REV. D

AS1895™/9

AEROSPACE STANDARD
 FLANGE, FEMALE, BUTT WELD
 TYPE II LOW PROFILE

ISSUED 1985-12 REAFFIRMED 2013-01 REVISED 2021-03

FIGURE 1 - TYPICAL SECTION

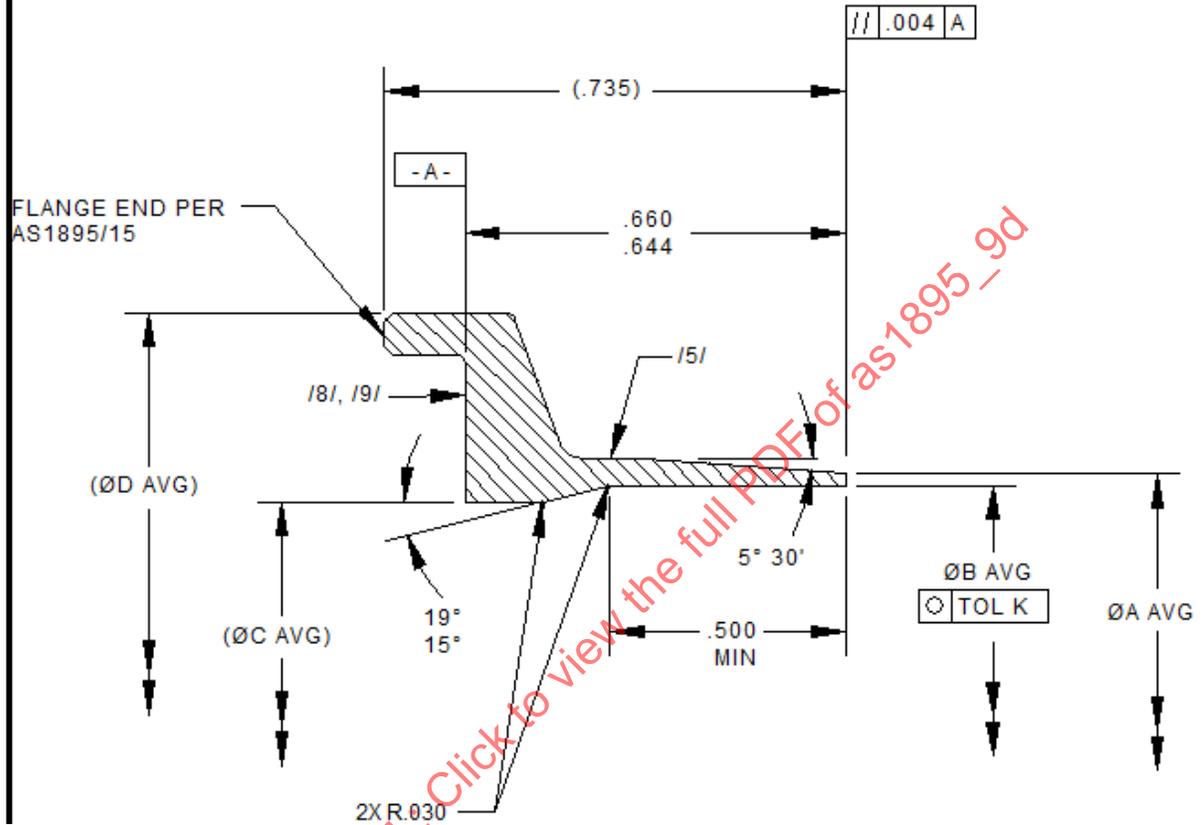
GRAPHICS REDRAWN. CIRCULARITY REQUIREMENT REMOVED FROM ØA. PERPENDICULARITY REQUIREMENT REMOVED FROM REFERENCE ØC. TABLE 1 REDRAWN TO ADD 'REF' TO DIM C AND D. NOTE 3 REVISED TO STATE CURRENT QML NOTE. GENERAL UPDATING OF SPECIFICATIONS BEING SPECIFIED HEREIN. CHANGE BAR NOTE REVISED. NOTE 17 ADDED.
